INCREASED CAPACITY SPENT FUEL RACKS  
NO. 1 UNIT  
SALEM NUCLEAR GENERATING STATION  
DOCKET NO. 50-272

Public Service Electric and Gas Company hereby submits additional information in support of its application to increase the spent fuel storage capacity at the Salem Nuclear Generating Station. This information is in response to discussions held with members of your staff.

### SALEM NUCLEAR GENERATING STATION

FIGURE 1

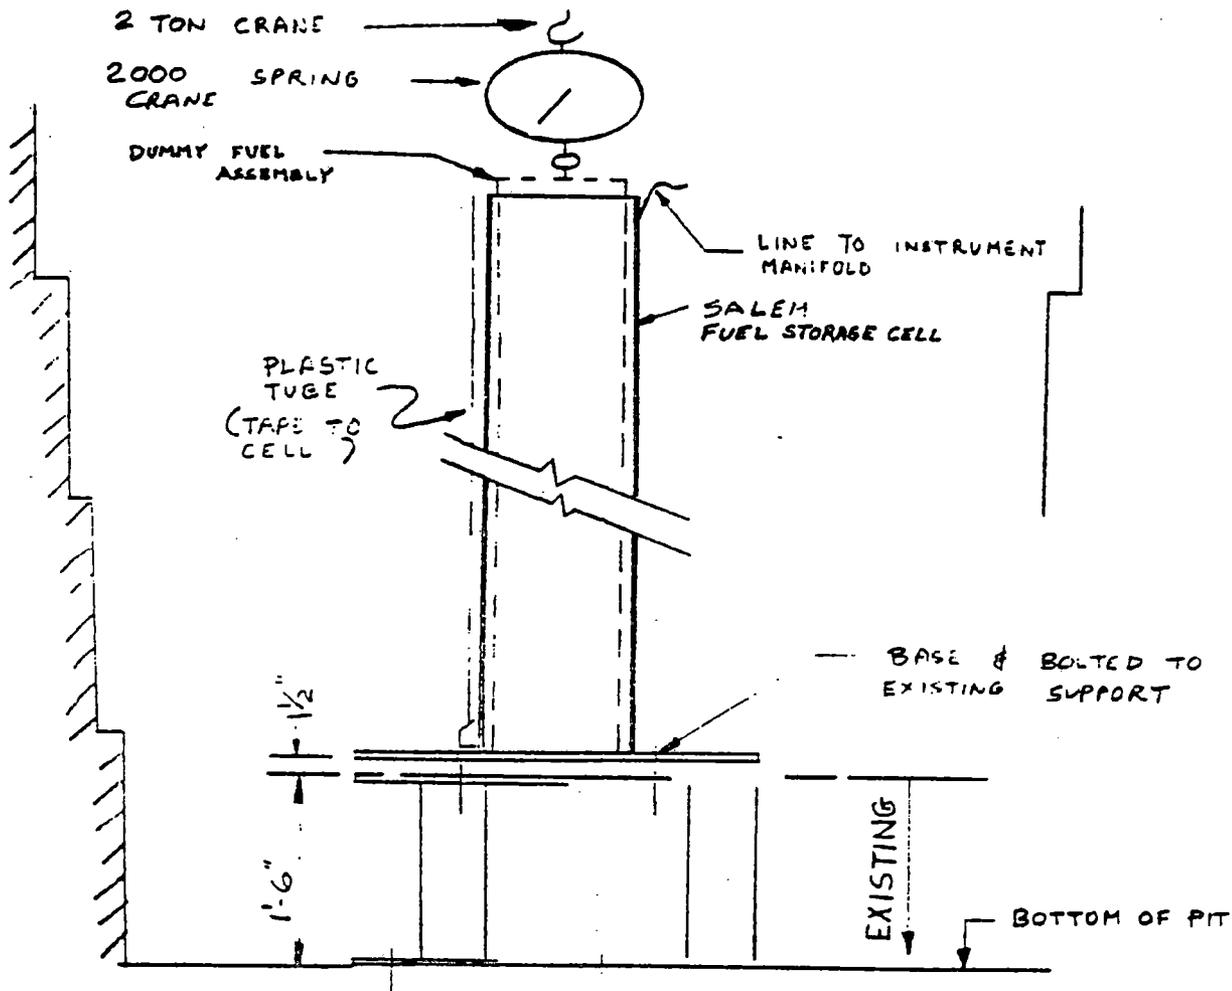
An experiment was set up as shown in Figure 1. A production fuel storage cell was mounted on a base plate, supported in a vertical position. The void space containing the Boral was vented to the inside of the cell at the bottom closure weld, and was connected to an instrument manifold at the top closure weld. The instrument manifold consisted of a 30" mercury manometer for pressure measurement, three needle valves for pressurizing gas flow control, and a 0-30 psi pressure regulator. A dummy fuel assembly was suspended in the fuel storage cell, hung from an overhead 2 ton crane with a 2000 lb. spring scale to allow measurement of friction withdrawal loads. The fuel bundle was instrumented with five (5) strain gauges at the midspan of the second and third grids of the fuel bundle. The gauges were intended to measure deformations between opposite sides and across one face of the bundle.

In order to simulate the first part of Case I, the valve at the top of the void space was closed, and the cell was filled with water. The internal pressure was measured at water heads of 6', 9', and a full condition. The maximum internal pressure generated was 1.8 psi in the void space. This pressure produced slight inward deformation of the inner shroud. Upon venting the void space, the inner shroud returned to the original position. The conclusion is that a cell with a leak at the lower closure weld will not have the inner shroud collapse due simply to filling the spent fuel pool with water.

The test for the second part of Case I, executed after completing the Case II test, started with the void space between shrouds at equilibrium with the water inside the cell. The instrument manifold was used to slowly pressurize the void space to a maximum value of 5.6 psi. At the maximum pressure, gas bubbled from the holes at the bottom closure weld in a manner similar to that which would occur in the spent fuel pool. Between the pressures of 3 and 5 psi the inner shroud underwent large plastic deformations. After release from a maximum pressure of 5.6 psi, the throat dimension of the inner shroud was 3.2" at a distance of 3' from the upper end of the cell. It is concluded that a fuel cell that has been fully pressurized by corrosion offgassing in an empty condition will be unusable for fuel storage.

For simulation of Case II, a prototype 15 x 15 PWR fuel assembly with the same overall dimensions as the Salem design was instrumented with strain gages and placed in the fuel storage cell. After filling the cell with water, the void space between shrouds was pressurized in steps to a maximum pressure of 5.6 psi.

At a pressure between 2.5 and 3 psi the inner shroud bulged inward to contact the fuel bundle. As further pressure was applied, the bundle withdrawal forces increased. At the maximum pressure of 5.6 psi the measured friction force between the inner shroud and bundle was 1200 lbs. After venting the void space the permanent inner shroud inward deformation was measured to be 0.4 inch, allowing the bundle to be withdrawn without friction force loading from the fuel cell. It is concluded that, after relieving the inner shroud pressure, the cell would be usable for storage of a fuel assembly. The maximum fuel rod deformation measured using strain gages during Case II, was 0.19". Extrapolating the prototype 15 x 15 fuel to the 17 x 17 Salem configuration, a maximum stress of 20 ksi was conservatively calculated in the most highly stressed fuel pin wall. This is substantially below the yield stress of 30 ksi for unirradiated Zircaloy-4 tubing. No damage to the fuel assembly would be anticipated.

Figure 1. Surveillance Program Samples Positioned In High Density Storage Rack.

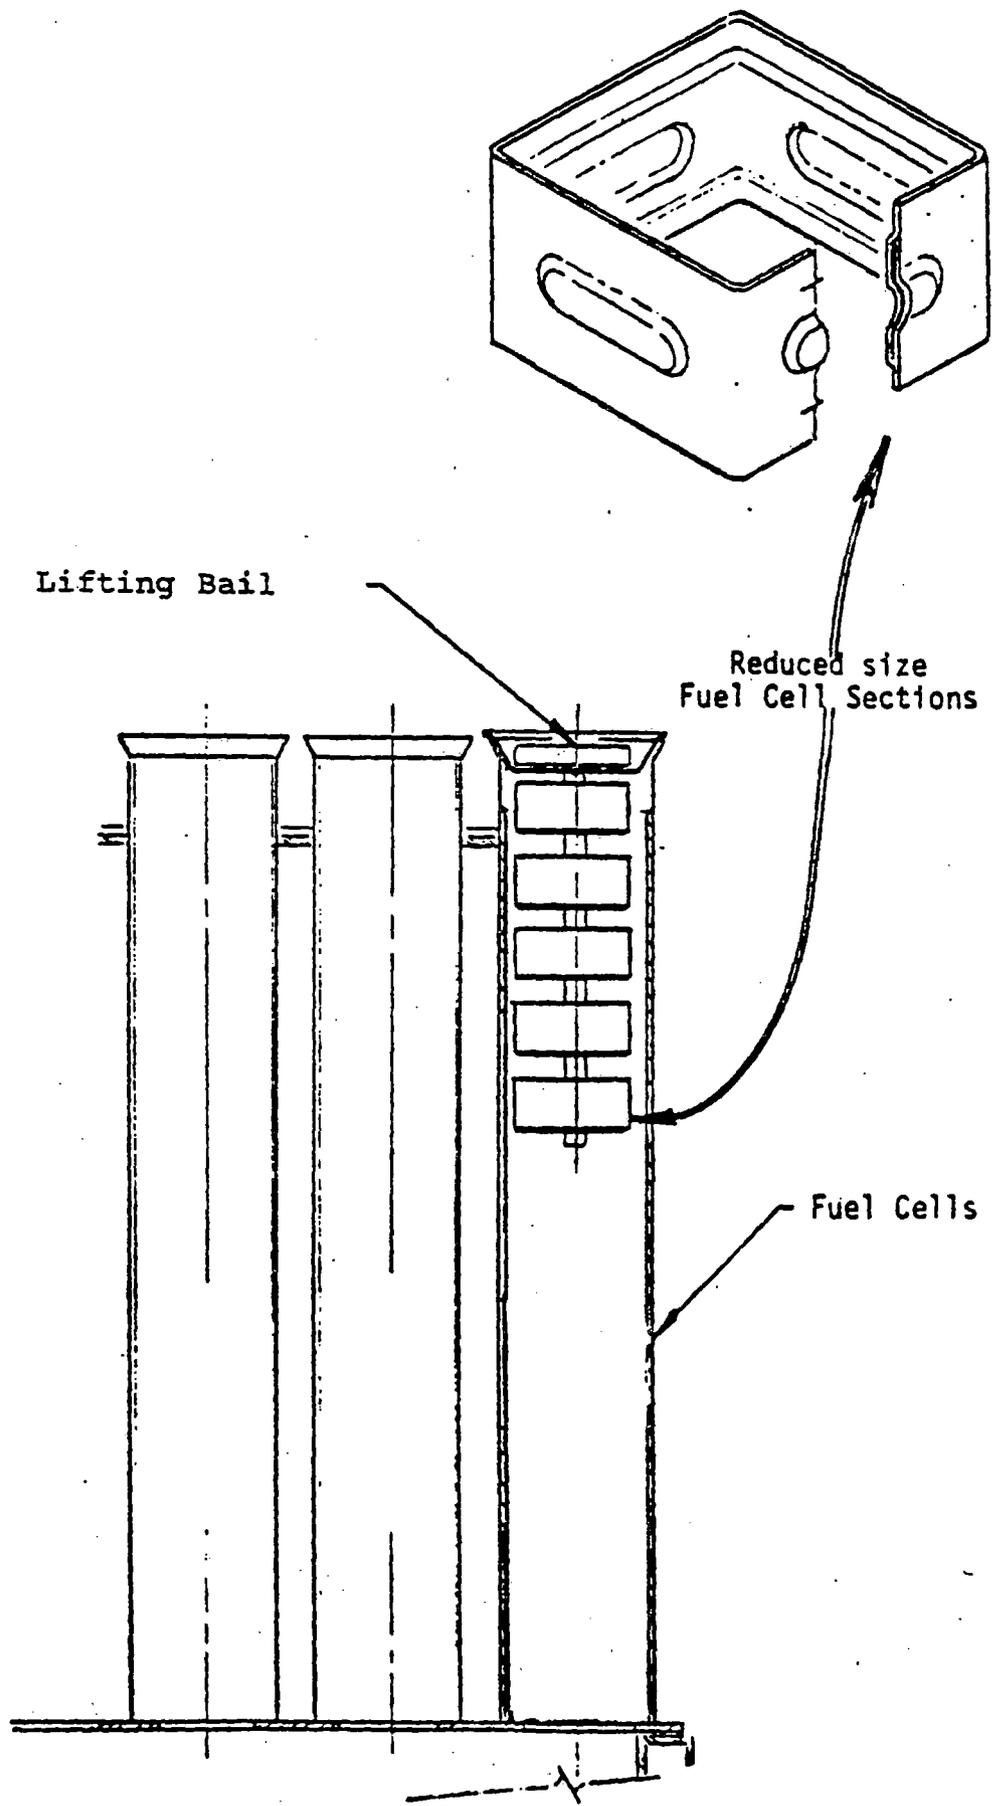
The samples will be placed in an empty fuel storage cell in the racks as shown on Figure 1. The test sections will be positioned in a stainless steel fixture such that plane of the Boral plates is in the vertical direction. After examination, they will be moved to an empty fuel storage cell position near the most recent off-loaded fuel.

FIG. 1 FUEL ASSEMBLY DEFLECTED SHAPE FOR STATICALLY APPLIED SEISMIC LOADS

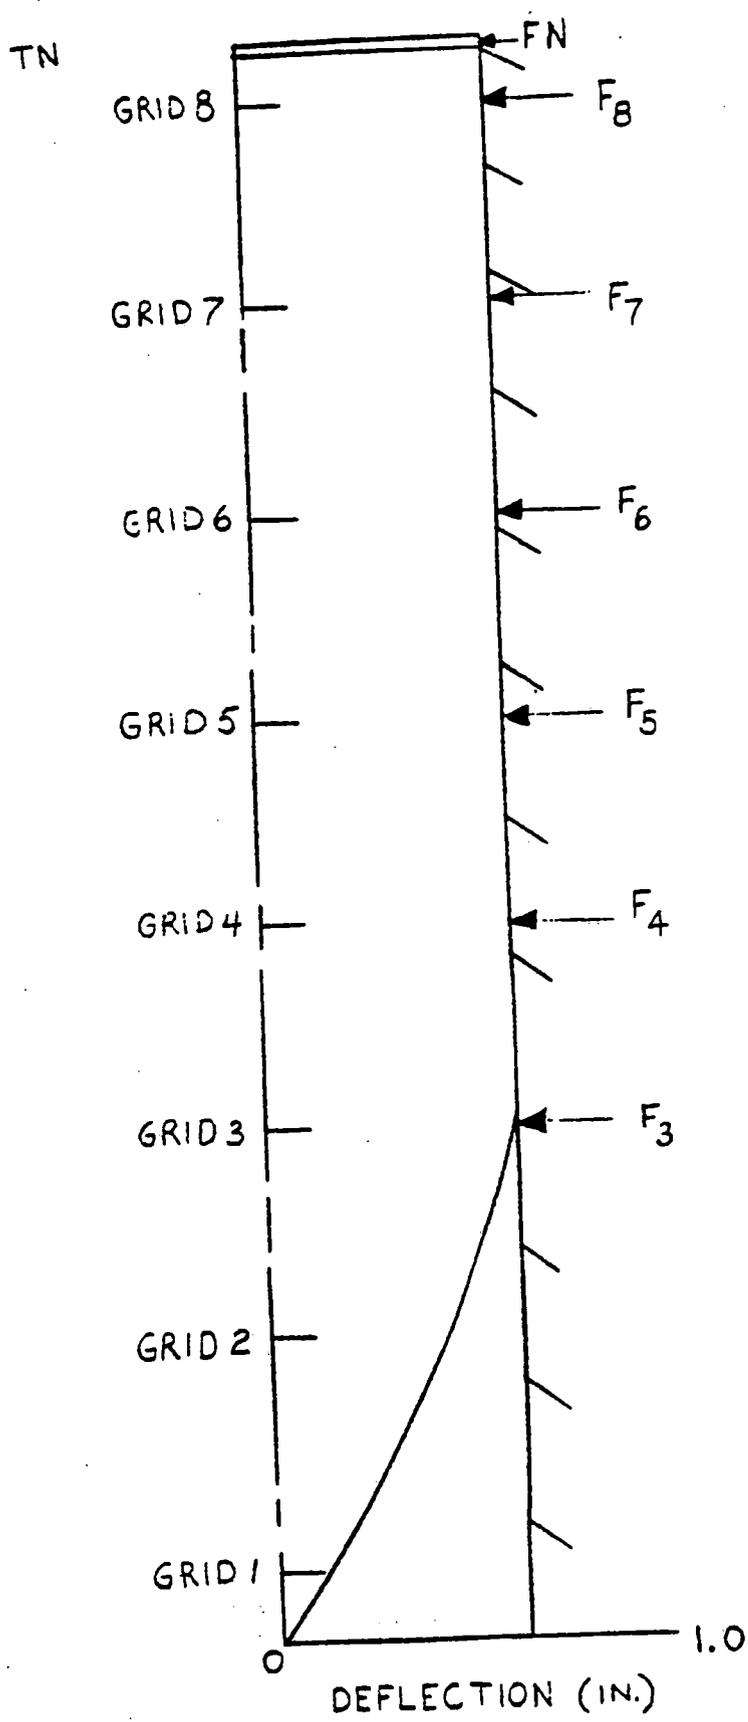
The fuel assembly was assumed to be positioned in the storage racks such that it was initially in contact with one of the storage cell walls. Based on that assumption, the maximum attainable fuel assembly deflection at any location was 0.60 inches. Static loads were applied to the fuel assembly grids to simulate the fuel assembly inertial forces.

The fuel assembly deflected shape resulting from the calculated load distribution is presented in Figure 1, and indicates that the fuel assembly experiences grid to cell wall contact at the third and higher grid elevations. The fuel assembly component maximum stresses obtained from the analysis were compared to the established allowable limit and are presented in Table 1.

For the seismically induced fuel assembly impact forces, it can be concluded based on a fuel assembly deflected shape that the stress margins for the various fuel assembly components are acceptable. It can also be concluded that the minimum experimental grid strength was substantially greater than the estimated grid maximum impact force of 540 lbs.
